BALTIMORE COUNTY PUBLIC SCHOOLS

ADDENDUM NUMBER _1_

BID NAME: NEW SCHOOL CONSTRUCTION LANSDOWNE ELEMENTARY
SCHOOL/DEMOLITION OF LANSDOWNE ELEMENTARY
SCHOOL__

BID NUMBER: **MBU-516-17**

SK- C -13

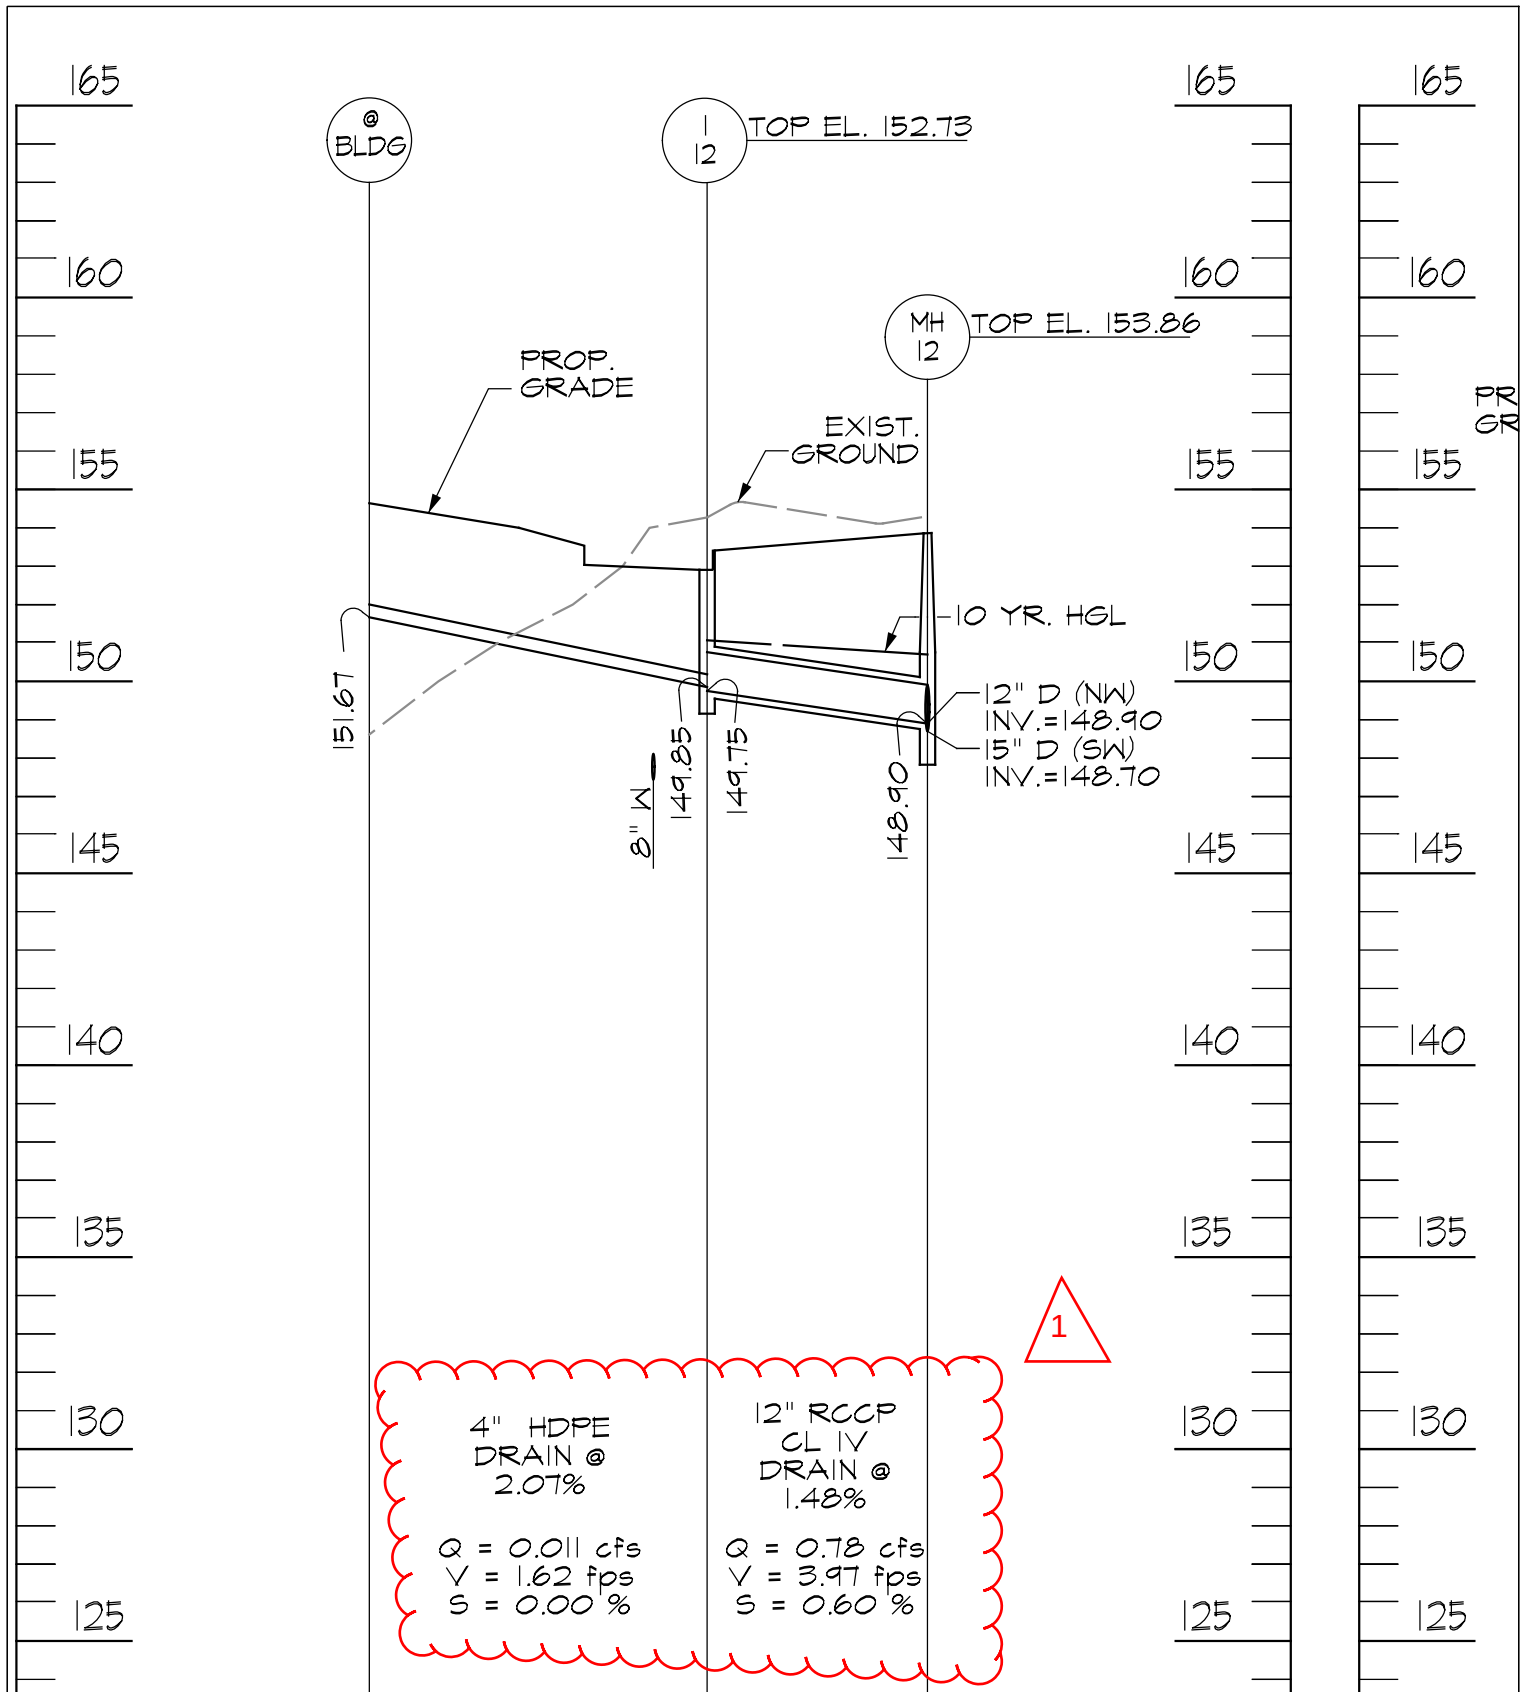
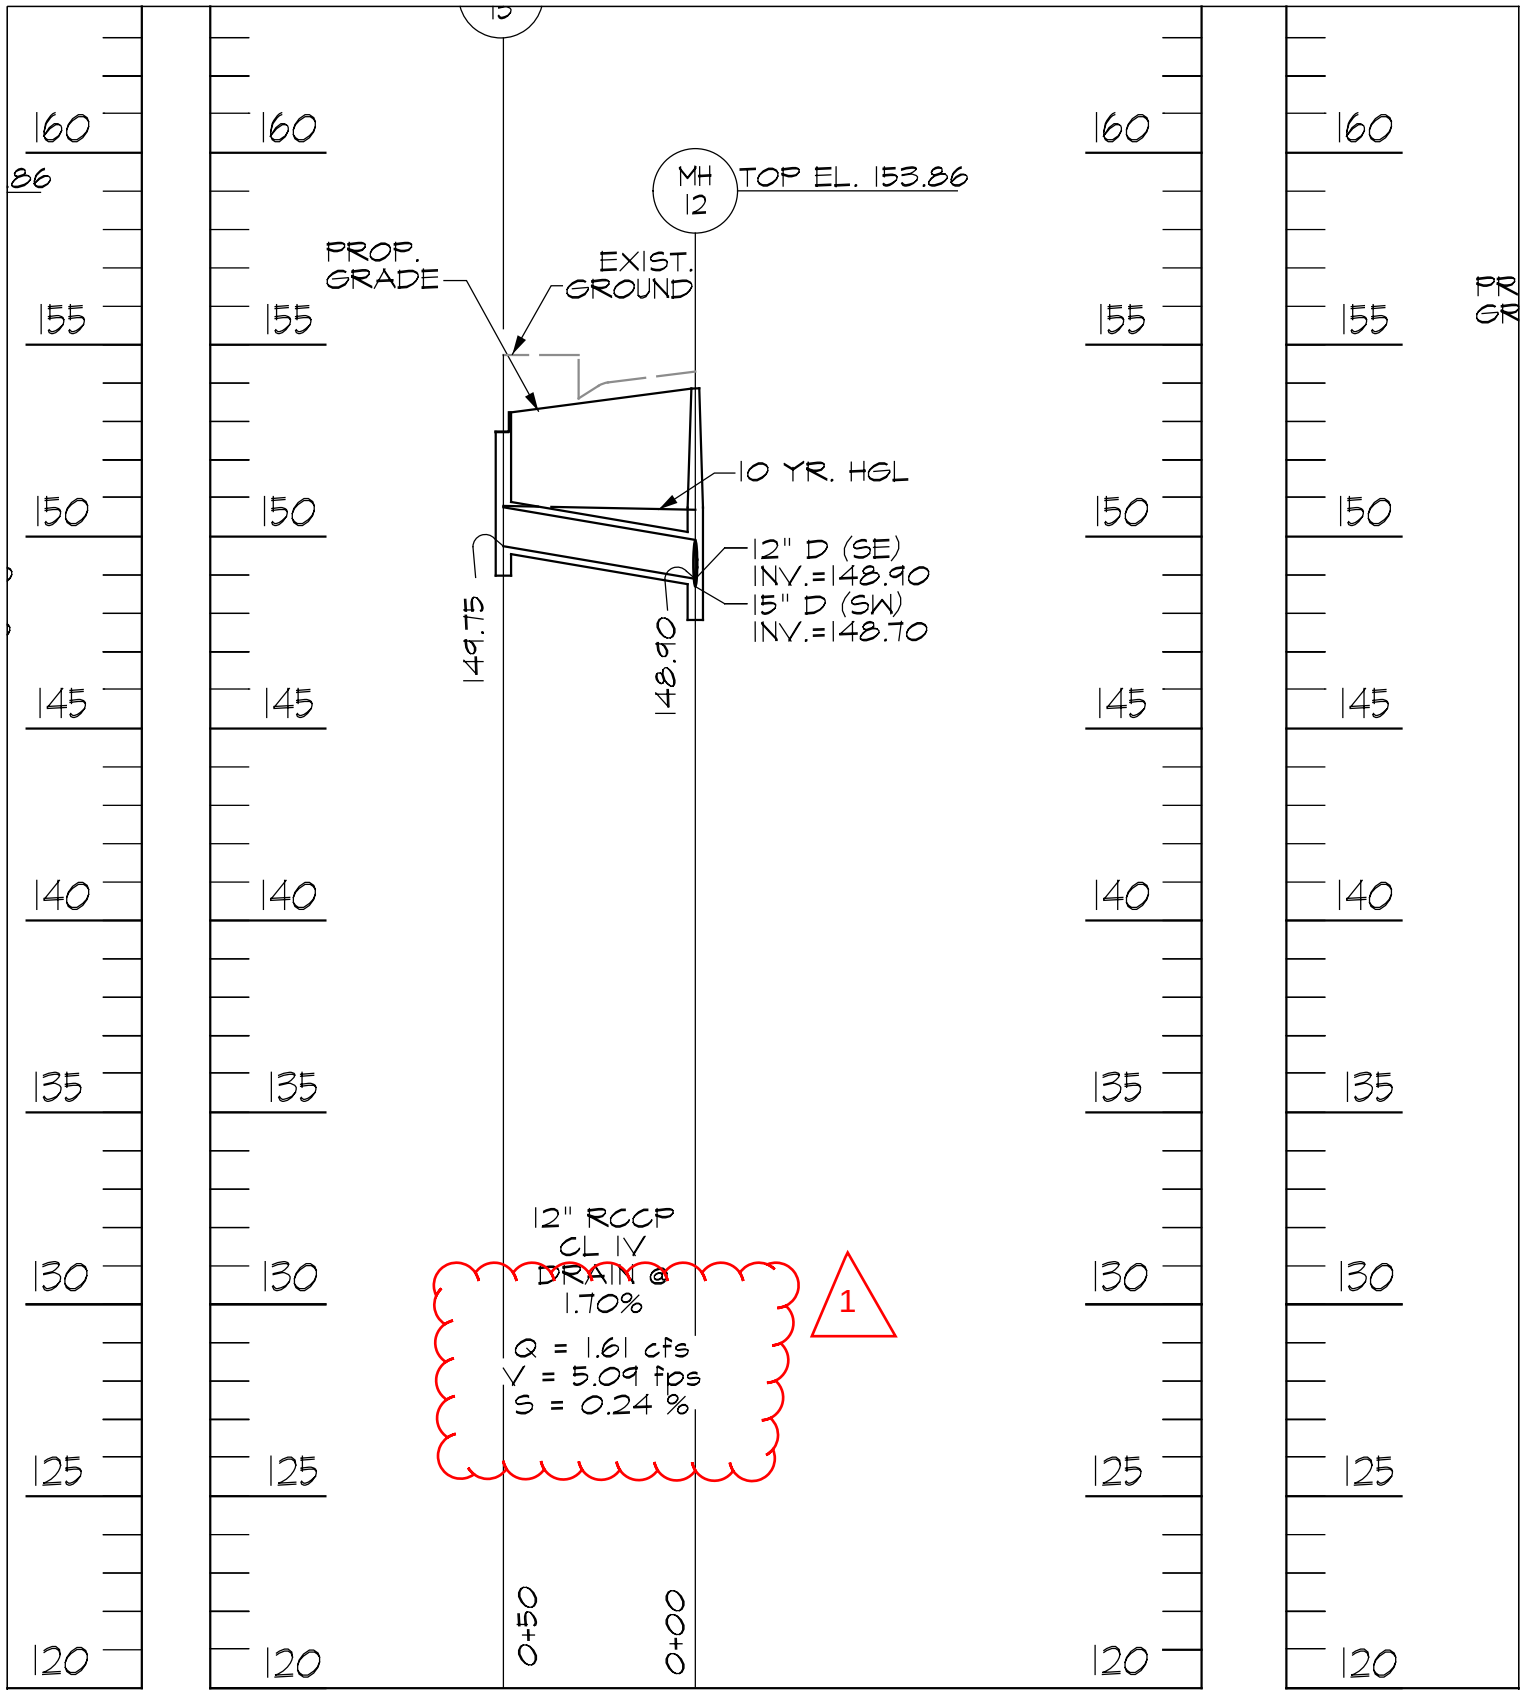
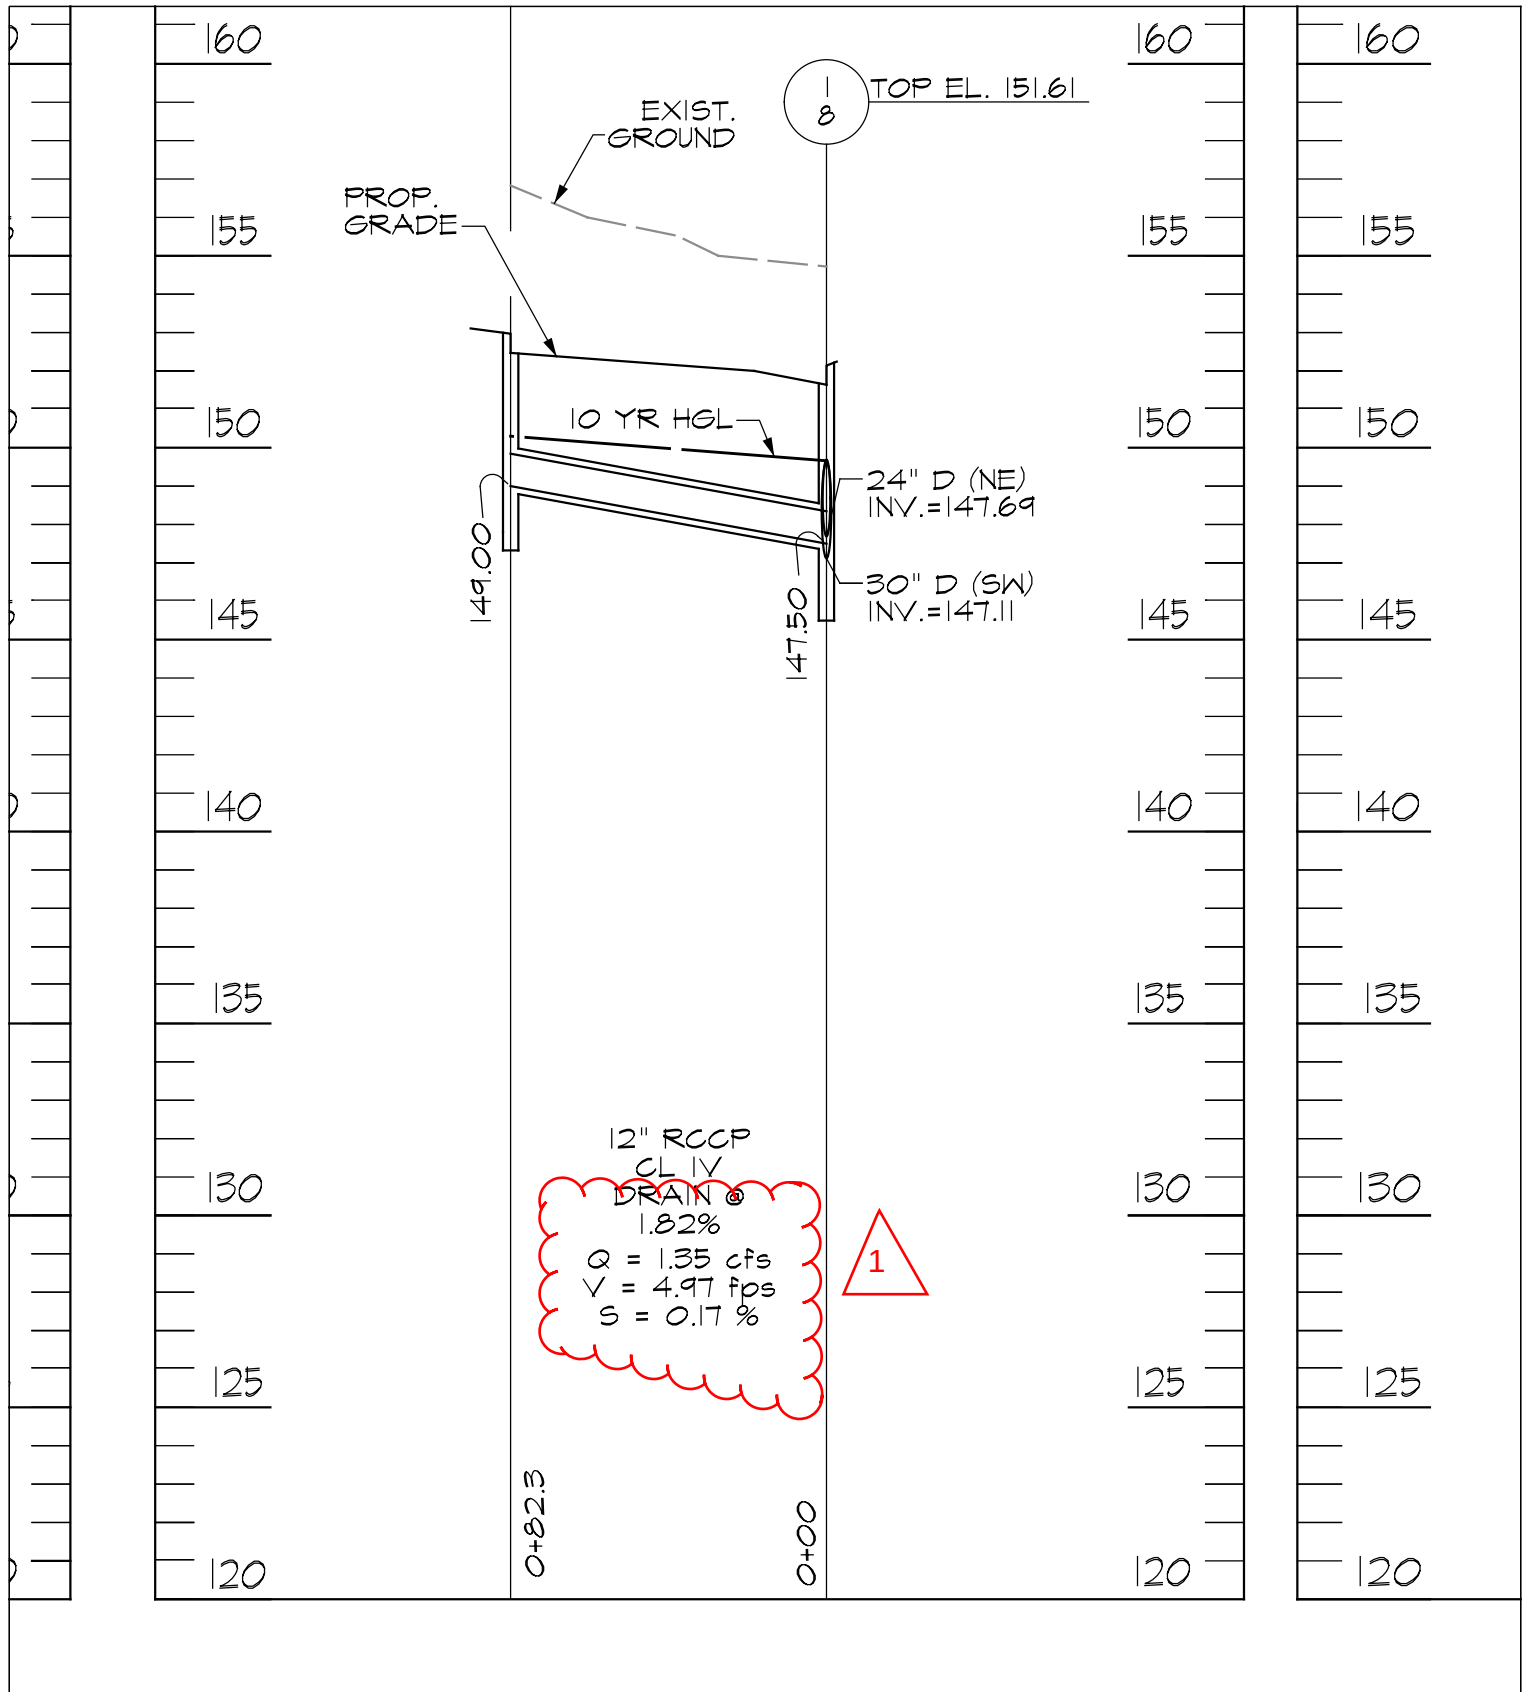
- 3.14. SHEET C-4.6, UTILITY PROFILES
REVISE: Storm Drain Profiles as indicated in attached sketch SK-C-13 – 13I.
- 3.15. SHEET C-5.1, STORM DRAIN DRAINAGE AREA MAP
REVISE: Storm Drain Design Data chart as indicated in attached sketch SK-C-14.
